The amendment revises the Technical Specifications to increase Maximum Average Planar Linear Heat Generation Rate (MAPLHGR) operating limits by allowing credit for core spray heat transfer.

PILGRIM NUCLEAR POWER STATION
AMENDMENT TO FACILITY OPERATING LICENSE

Amendment No. 59
License No. DPR-35

SUPPORTING AMENDMENT NO. 59 TO FACILITY LICENSE NO. DPR-35

FIGURE 3.11-1
 MAXIMUM AVERAGE PLANAR LINEAR HEAT GENERATION RATE
 VERSUS
 PLANAR AVERAGE EXPOSURE
 FUEL TYPE 8DB219L

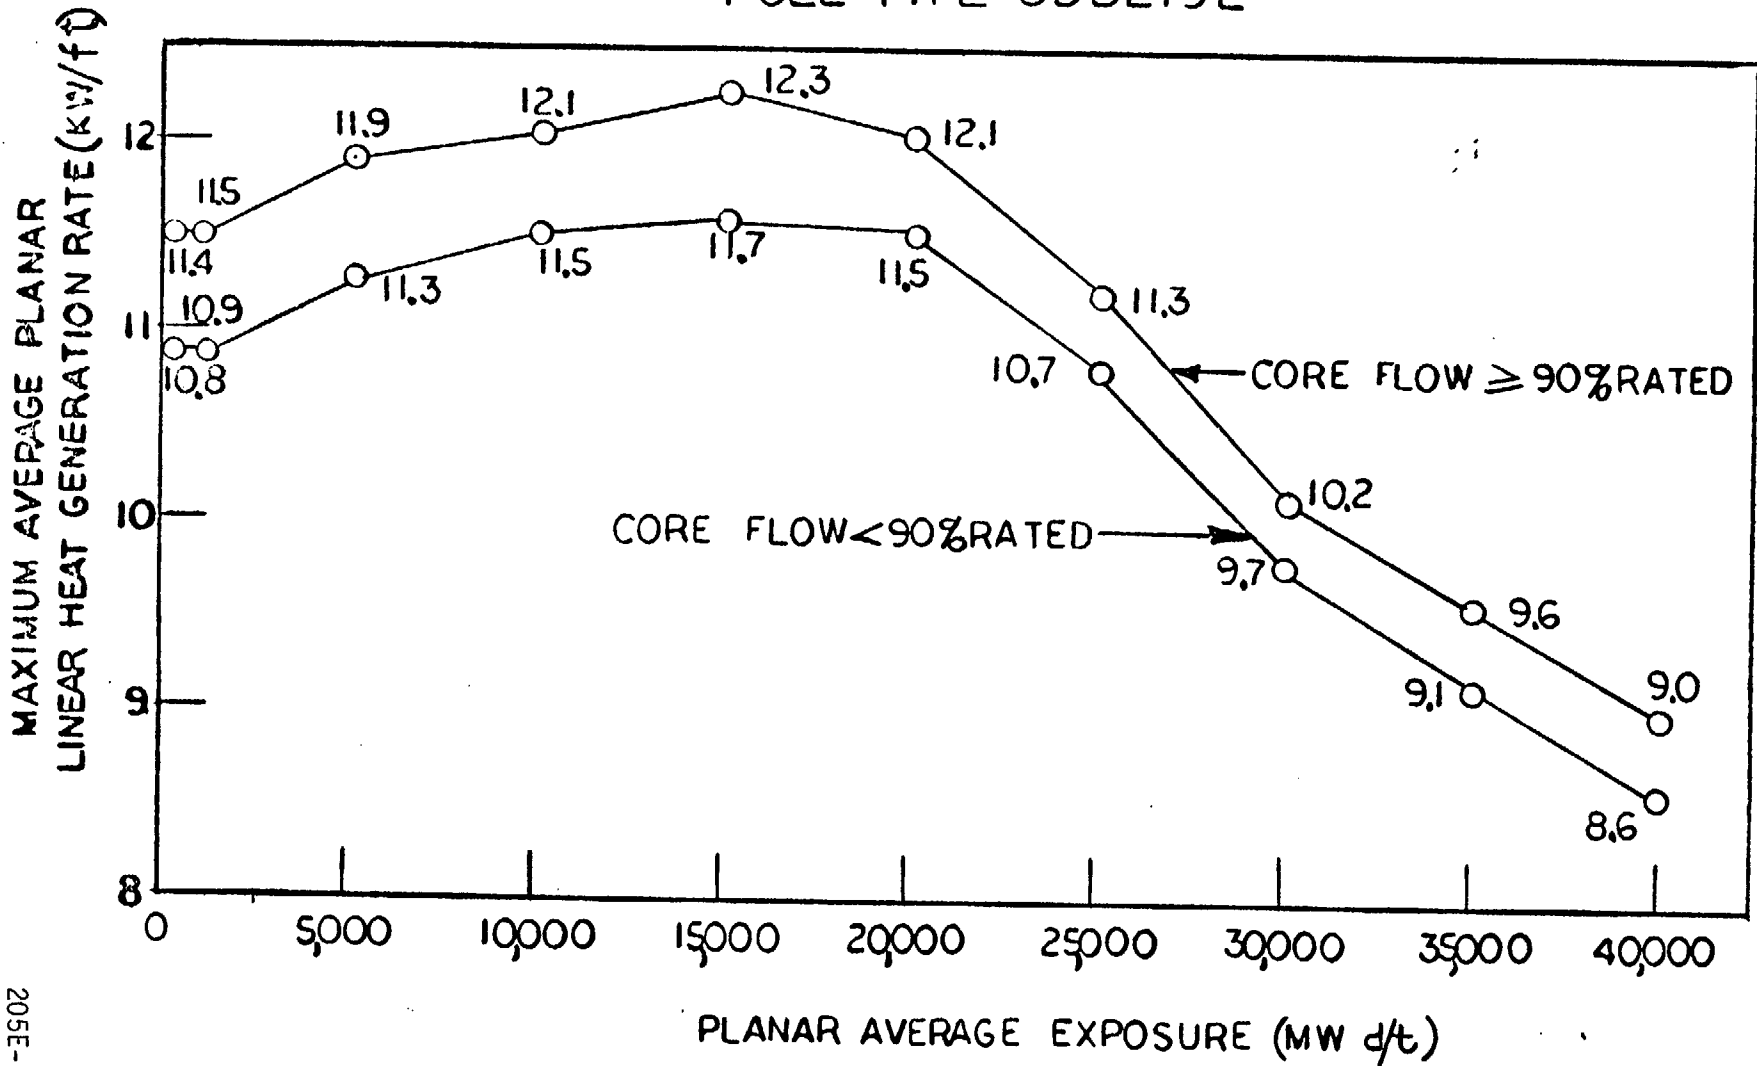
Based upon the results of the most recent core spray sparger inspections, the licensee has requested revisions to its TS to restore credit for core spray heat transfer and to eliminate the MAPLHGR reduction factors for Cycle 6 operation.

During power operation with both recirculation pumps operating, the APLHGR for each type of fuel as a function of average planar exposure shall not exceed the applicable limiting value shown in Figures 3.11-1 through 3.11-6. The top curves are applicable for core flow greater than or equal to 90% of rated core flow. When core flow is less than 90% of rated core flow, the lower curves shall be limiting. If at any time during operation it is determined by normal surveillance that the limiting value for APLHGR is being exceeded, action shall be initiated within 15 minutes to restore operation to within the prescribed limits. If the APLHGR is not returned to within the prescribed limits within two (2) hours, the reactor shall be brought to the Cold Shutdown condition within 36 hours. Surveillance and corresponding action shall continue until reactor operation is within the prescribed limits.
